UPDATE NOTE

from firmware V4 to firmware V5

Mini Motor S.P.A.

FW-UPD-V5-EN

Figure 1. The BSI proposes the firmware update from V4 to V5

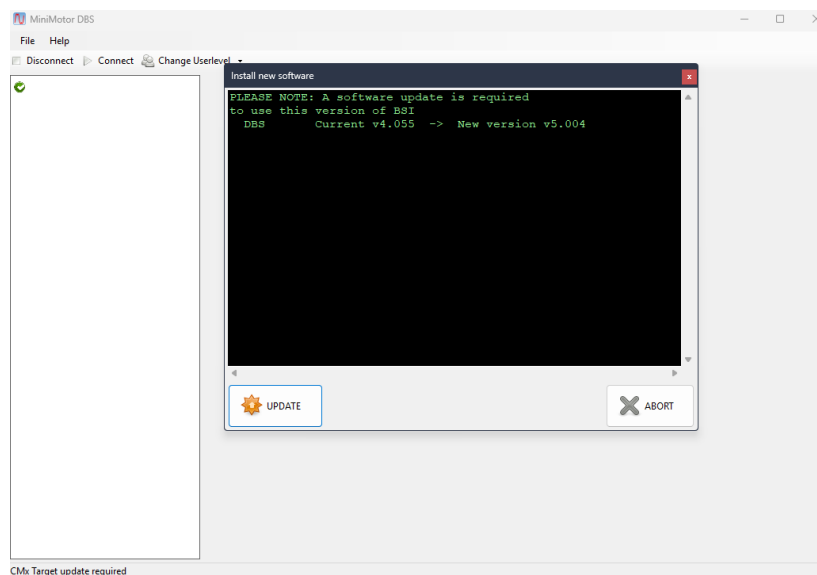
Open the BSI of version 5.004 and connect to the motor. The BSI notices that the firmware on board is older than its own and opens the **Install new software** window, with the current and the new version ([Figure 1](#)).

Press **UPDATE** and wait for the process to finish, then press **CLOSE**. It is the same procedure as any firmware update, also described in the Parametrization Interface chapter of the manual.

Figure 2. Protocol stack update: Fieldbus Protocol page and Fieldbus selection window

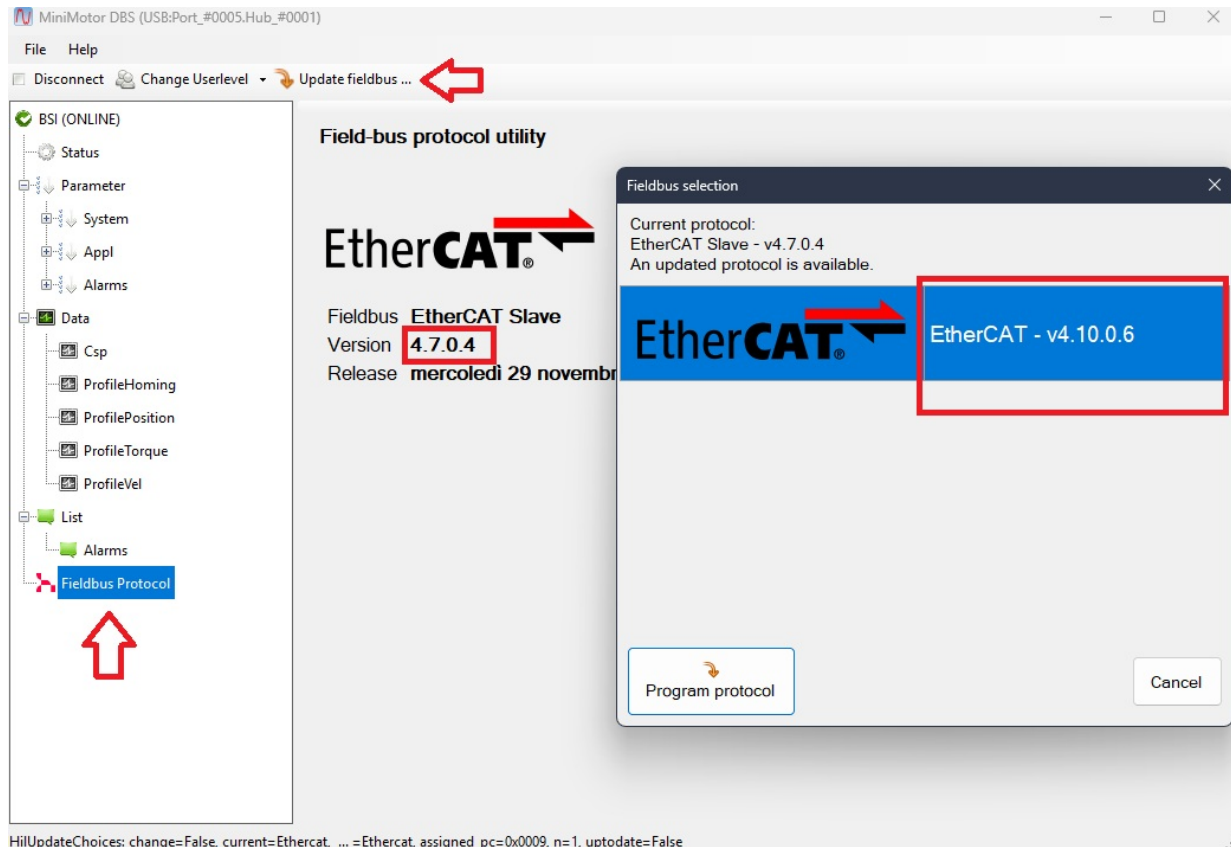
Connect to the motor again with **Connect**. In the tree on the left select **Fieldbus Protocol**, or press **Update fieldbus...** in the top bar, available at any user level (Figure 2).

The **Field-bus protocol utility** page shows the protocol installed on the fieldbus board and its version. In the **Fieldbus selection** window the BSI reports the current protocol and, below it, the message **An updated protocol is available**: it means the stack on board is the old one.

1. Select in the list the proposed protocol, with the new version. In the example in the figure the motor has EtherCAT, with stack 4.7.0.4, and the BSI proposes **EtherCAT - v4.10.0.6**.
2. Press **Program protocol**.
3. Wait for the programming to finish: at the end the motor restarts on its own. Do not disconnect it or remove the power supply before the restart.
